Re: Florida Power & Light Company
Proposed Turkey Point Units 6 and 7
Docket Nos. 52-040 and 52-041
Response to NRC Request for Additional Information Letter No. 082 (eRAI 7811)
SRP Section 02.05.04 – Stability of Subsurface Materials and Foundations

NRC RAI Letter No. PTN-RAI-LTR-082

NRC RAI Number: 02.05.04-27 (eRAI 7811)

NRC RAI Number: 02.05.04-36 (eRAI 7811)

Figure 1 Shear Wave Velocity Profile

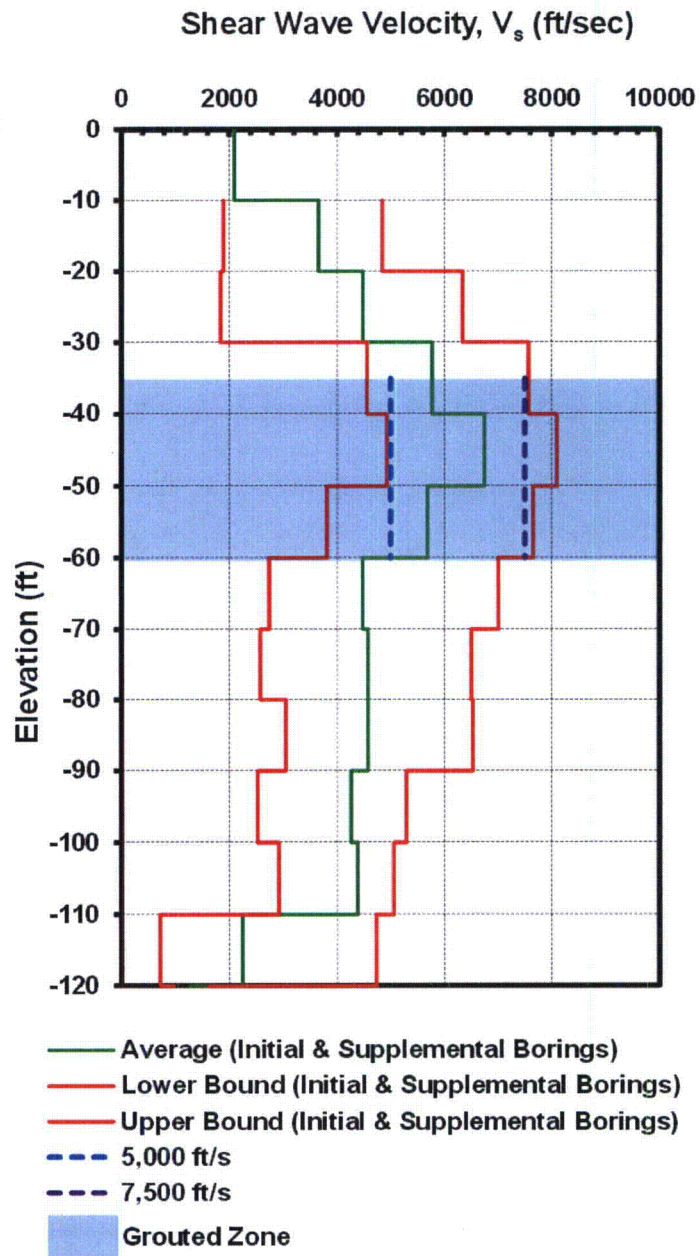
FSAR Subsection 2.5.4.5.4 states that grouting will be conducted beneath the nuclear island between the elevations of approximately -35ft and -60 ft to form a grout plug for construction related groundwater control. In accordance with 10 CFR 100.23 and RG 1.208, please describe what inspection and test programs will be conducted for ensuring the shear wave velocity post grouting is consistent with the shear wave velocity used in the site response analyses you performed in your previous calculation of the GMRS in FSAR Subsection 2.5.2.6.

The main objective in response to this request is to compare the post-grouting shear wave velocity in the grouted zone (El. -35 feet to El. -60 feet) to the pre-grouting shear wave velocity profiles as given in Figures 1 and 2, and show that any variation in shear wave velocity due to grouting is within the variability considered in site response analyses (Figure 3) and within the variability considered elsewhere in the FSAR (i.e., Subsection 2.5.4).

The lower end of the acceptance criteria (5000 ft/s) is assigned such that it is substantially lower than the FSAR best estimate for the interval of El. -35 feet to El. -60 feet, and larger than the lower bound shear wave velocity (4945 ft/s) for the interval of El. -35 feet to El. -60 feet (Figure 1). The higher end of the acceptance criteria (7500 ft/s) is lower than the upper bound of shear wave velocity (7575 ft/s) for the interval of El. -35 feet to El. -60 feet (Figure 1).
